AMENDMENT NO. 3 MAY 2026
TO
IS 2553 (PART 1) : 2018 SAFETY GLASS — SPECIFICATION
PART 1 ARCHITECTURAL, BUILDING AND GENERAL USES
(Fourth Revision)

Amendment No. 3 to IS 2553 (Part 1) : 2018

FIG. 20 SPHERICALLY CURVED GLASS

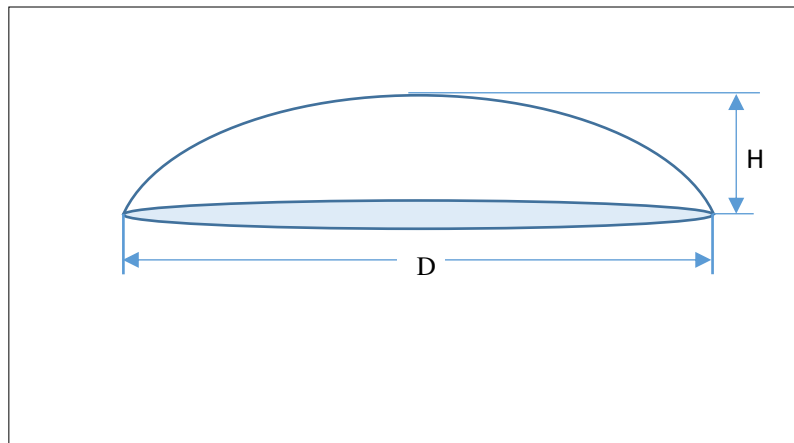
(Amendment No. 1, Page 1, clause 5.2.2.3.3) — Insert the following at the end:

‘5.2.2.3.4 Dimensional requirements specific for spherically curved toughened glasses

The spherically curved toughened glass shall satisfy the dimensional requirements as given below:

a) *Depth of curvature or crown height, H*

Place glass on hard flat surface and measure the vertical height (*see* Fig. 20) from base to apex using any calibrated ruler, thread or depth gauge in millimeters. The measured height shall lie within the ± 1.5 mm of the nominal height as declared by the manufacturer.
